Freetown Police Station

Town of Freetown ADA Transition Plan

August 2023

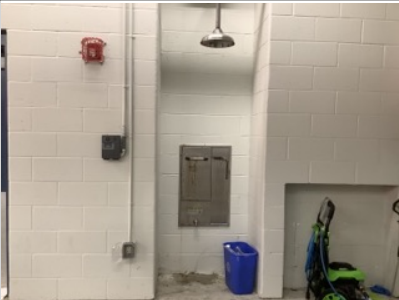
15	Single-User Toilet Room	1	A126	Doors, Doorways, & Gates	Toilet Room		Door requires > 5 lbs. of force to open	10 lbs	Adjust closers so doors do not require more than 5 pounds of force to open.	1	Labor	\$0
